***MODIFICATION REQUEST:  
Stages 2 and 3, Site 3 Mixed Use  
Development  
Australia Avenue, Sydney Olympic Park  
(MP 10\_0027 MOD 3)***

***Minor design changes and conversion of  
rooftop plant area into additional residential  
floor space***

Director-General's  
Environmental Assessment Report  
Section 75W of the  
*Environmental Planning and Assessment Act 1979*

**Figure 3: Proposed Level 30 (inc. plant)**

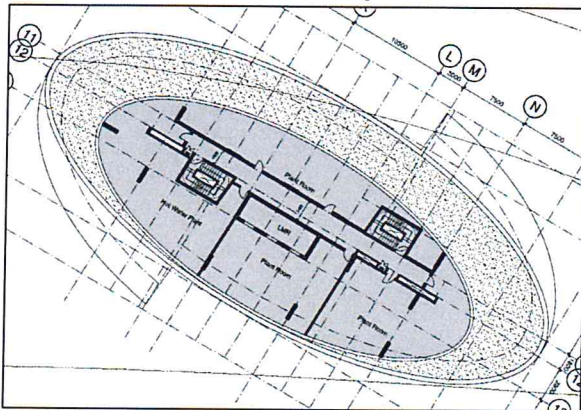
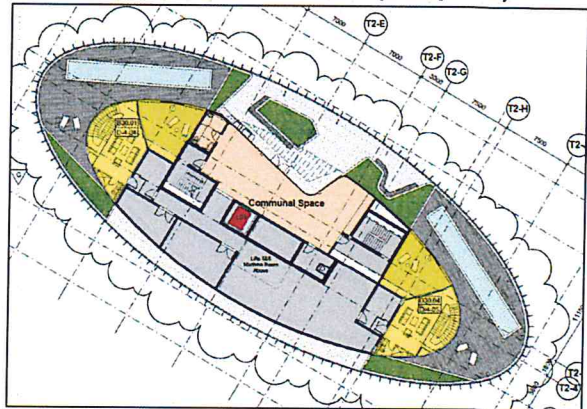
The rooftop plant area of Tower 2 has been reduced in size through detailed design work and the proponent is seeking approval to convert this surplus plant area into additional residential floorspace for the penthouses (living rooms, winter gardens and private open space with pools) and an additional communal area for residents (see **Figures 2 and 3**). The proposed additional residential floorspace is confined to the approved envelope for the rooftop plant area. The rooftop plant area is screened by a glazed curtain wall that extends 1.05 metres above the rooftop plant and therefore the proposed changes would have minimal built form impacts.

**Figure 5: Proposed Typical Vertical Slot Design**

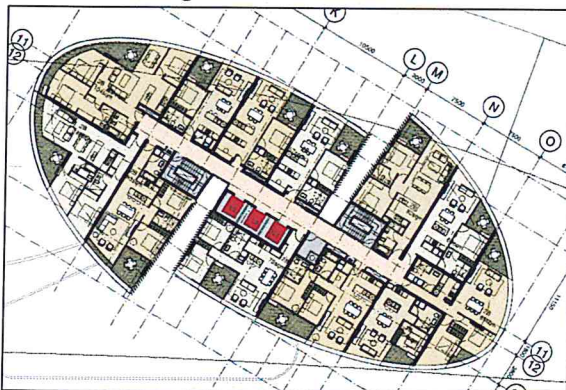
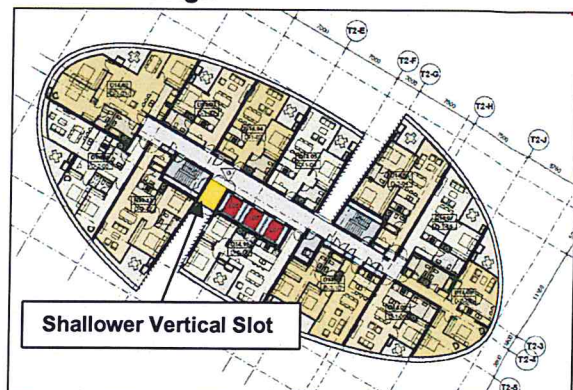
The proposed minor variations to the vertical slots (adjoining the lift core) for the two towers and the variation to the podium layout will not be visually discernible from Australia Avenue (see **Figures 4 to 7**). The proposed variations are sought to satisfy engineering and structural load requirements and improve circulation between the two towers. The vertical slots will be slightly shallower and the shape of the commercial and gym area on the podium will change, however, the general alignment along the Australia Avenue frontage will remain unchanged. The variations would result in a minor increase in gross floor area, however, these variations do not provide any additional habitable floorspace.

The department therefore considers that the proposed modifications are minor and would have negligible built form impacts.
